RE: UC-3 Culvert Extension, Horizon Coal Corporation, Horizon Mine, ACT/007/020-97D, Folder #2, Carbon County, Utah

Horizon Coal Corporation has submitted an amendment for extending Culvert UC-3 100 feet northward. The 36" culvert currently carries Jewkes Creek beneath the lower pad area and around the sedimentation pond. The purpose for the culvert extension is to alter the truck turnaround radius, thus enlarging the lower facilities pad for safety reasons.

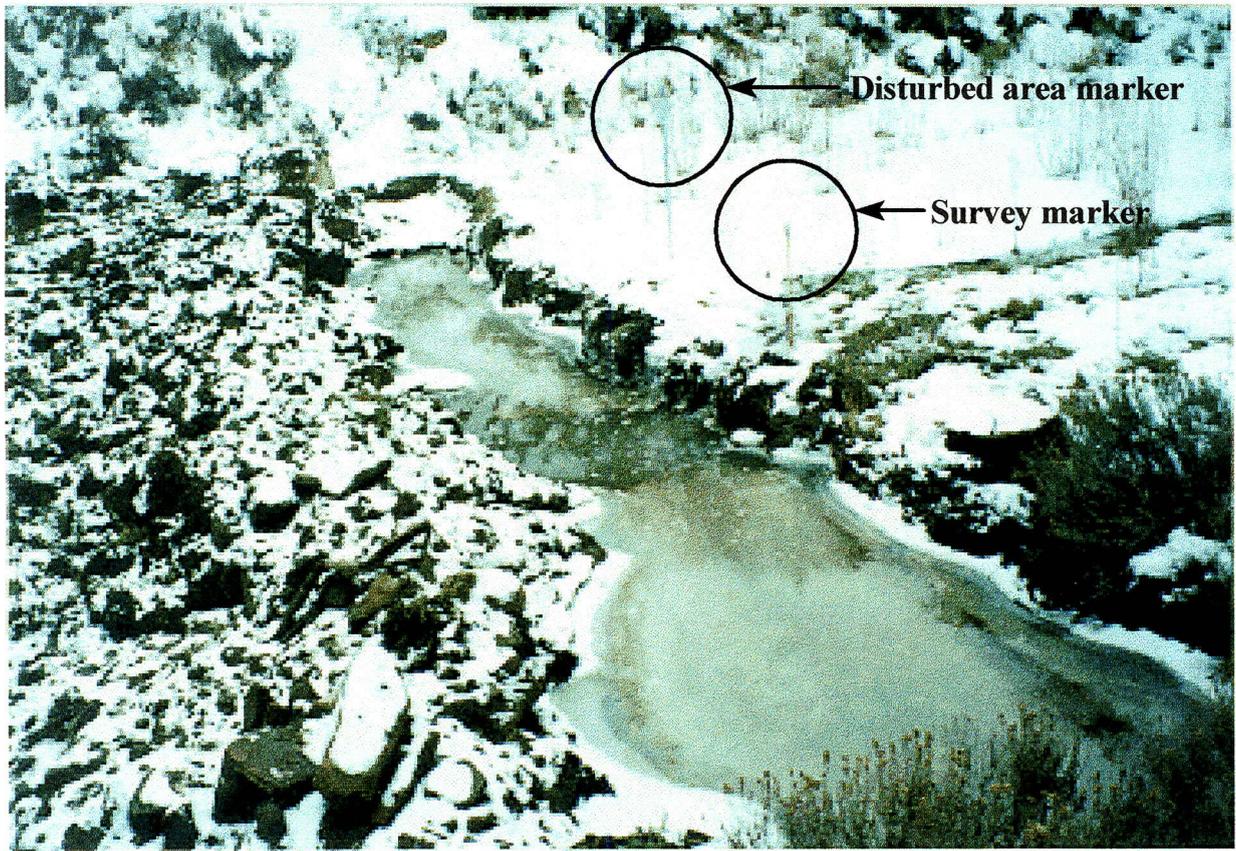
The disputed area for the culvert extension lies northward of the current disturbed area boundary as shown in the approved MRP and on photographs (see Figure 1 of this TA memo) taken during construction last fall, 1996. The placement of the disturbed boundary marker as shown in Figure 1 is consistent with the marked disturbance boundary as shown in the original approved Mine Reclamation Plan. However, Horizon claims this area as part of the established disturbance area because of errors in surveying that were corrected during a survey performed during the summer of 1997. Drawing A, Appendix 3-9, shows the revised disturbance boundary as it exists in the field after the 1997 survey.
